Re: Lot 334 SP193431, 84-160 Christensen Road South, STAPYLTON QLD 4207
RESPONSE TO INFORMATION REQUEST,
Council Ref: COM/2024/32
ADG Ref: 27584 / C L001

ADG Engineers provides the following responses to relevant items within the CoGC information request received by email on the 20th March 2024 associated with Lot 334 SP193431, 84-160 Christensen Road South, STAPYLTON QLD 4207.

ADG REVISED PRELIMINARY CIVIL DRAWINGS

HYDRANT DECOMMISSIONING PLAN

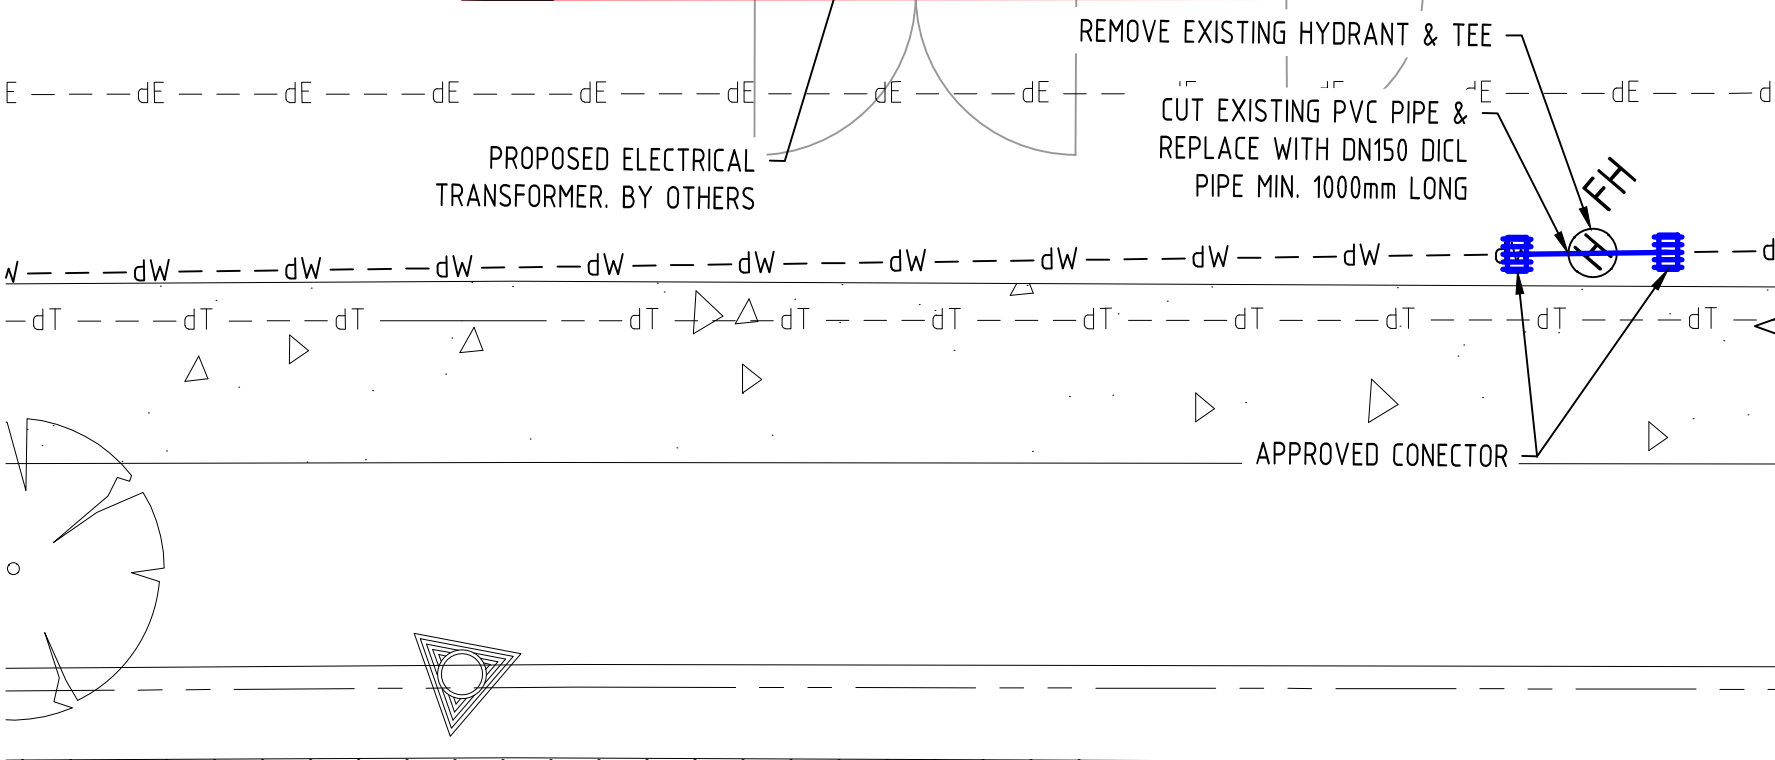
1. Change all pipe work to DICL in 'Cut in Connection Detail'. No new uPVC to be installed for cut in works.
2. Label and identify the DN100 flange plate (located immediately to the right of the upstream 40mm valve) on the 'Dual Stack Meter Assembly Detail'.
3. Water and Waste note the proposal to remove an existing hydrant, applicant to confirm reasoning behind hydrant removal/relocation. Furthermore, the applicant is requested to

refer to Section 8.8.8 Hydrant Spacing of the SEQ Code and provide RPEQ certification that the fire hydrant can be removed, relocated and still comply with the SEQ Code.

4. *If the hydrant removal/relocation can be reasonably justified, Water and Waste require RPEQ certified confirmation the affected properties will have no loss of fire coverage by the proposed relocation of the existing fire hydrant.*
5. *Water and waste will also require the existing section of watermain be replaced in the location of the proposed redundant fire hydrant if it is to be removed and does not support the blank plating of the existing hydrant tee.*

1. Noted. Material type changed to D1CL. Refer to Attachment A to this letter.
2. Item between valve and reducing tee is a DN100 blank flange, drilled and tapped to suit DN40 valve. Drawings updated to note as such.
3. The existing hydrant to be removed and replaced is due to the proximity to the proposed electrical transformer in accordance with AS2419.1:2021 S3.5.3.1, which requires a minimum distance of 10m from any transformer.
4. The proposed location ensures no loss of fire coverage in accordance with SEQ code.
5. Noted. Existing hydrant tee to be removed and replaced with pipe. This is shown on the revised plan - refer to Attachment A to this letter.

SERVICE LOCATING DOCUMENTATION

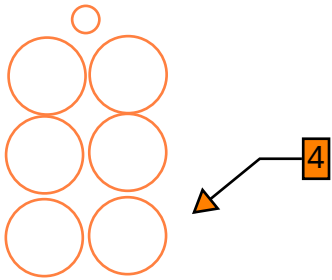
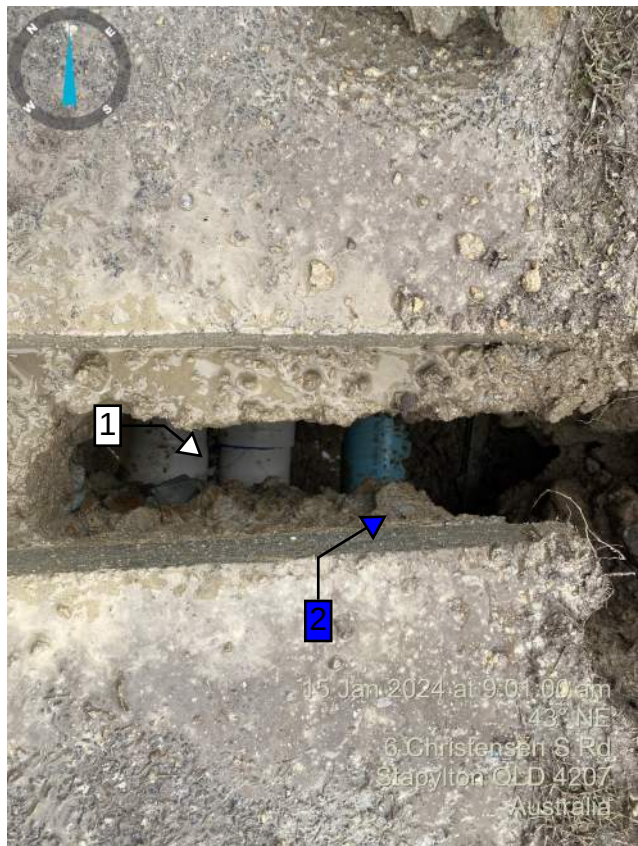
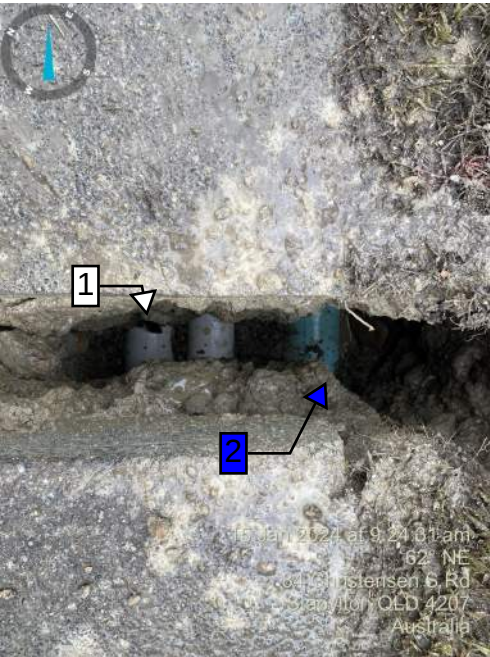
Proposed heavy duty VXO's for commercial/industrial premises over existing PVC water mains

Council note that the Applicant has proposed 2 x heavy duty VXO's which are located over Council's existing PVC water mains.

As per Section 5.4.2 of the SEQ Code, trafficable driveways into commercial and industrial premises are classed as road "carriageways" and as per Section 4.1 of the SEQ Code, CoGC requires ductile iron or class PN20 PVC-M pipes to be used for water mains in "carriageways".

To ensure compliance with the SEQ Code, the Applicant is requested to amend the provided plans as per the following:

1. Show replacing the existing water mains in an approved material under the proposed heavy duty VXO's, including a cross section showing the proposed cover to each water main under each proposed VXO. Noting the new pipework is required to extend a minimum 1m either side of the proposed VXO.

As agreed between Council officer Darren Munro and Michael Lepeaar of ADG, the existing PVC water main that passes under the proposed VXO (carriageway) has in excess of 1m cover and replacing the existing main with ductile iron is not necessary in this instance. Refer to Attachment B to this letter for service locating survey documentation supporting this.
